Re: Product Change Notification for Harwin product.

Please be advised that a few dimensions relating to male Gecko Latch horizontal connectors have changed by a small amount. The affected parts are in the following ranges:

The dimensional changes can be seen in these two extracts from the Technical Drawings:

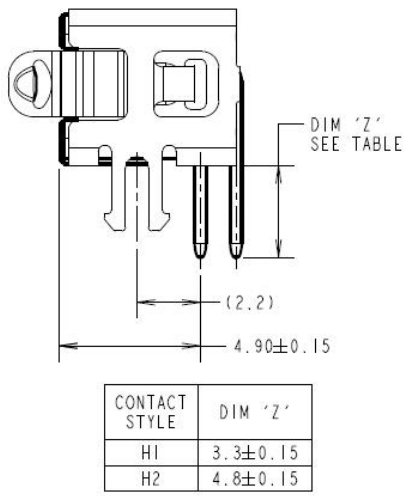
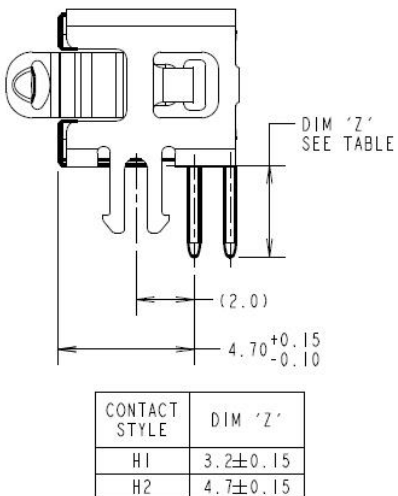
Previous dimensions	Revised dimensions												
 <table border="1"><thead><tr><th>CONTACT STYLE</th><th>DIM 'Z'</th></tr></thead><tbody><tr><td>H1</td><td>3.3 ± 0.15</td></tr><tr><td>H2</td><td>4.8 ± 0.15</td></tr></tbody></table>	CONTACT STYLE	DIM 'Z'	H1	3.3 ± 0.15	H2	4.8 ± 0.15	 <table border="1"><thead><tr><th>CONTACT STYLE</th><th>DIM 'Z'</th></tr></thead><tbody><tr><td>H1</td><td>3.2 ± 0.15</td></tr><tr><td>H2</td><td>4.7 ± 0.15</td></tr></tbody></table>	CONTACT STYLE	DIM 'Z'	H1	3.2 ± 0.15	H2	4.7 ± 0.15
CONTACT STYLE	DIM 'Z'												
H1	3.3 ± 0.15												
H2	4.8 ± 0.15												
CONTACT STYLE	DIM 'Z'												
H1	3.2 ± 0.15												
H2	4.7 ± 0.15

Product is already stocked and manufactured to the revised dimensions. The Technical Drawings have been updated on the website – catalog revisions will follow at a later date.
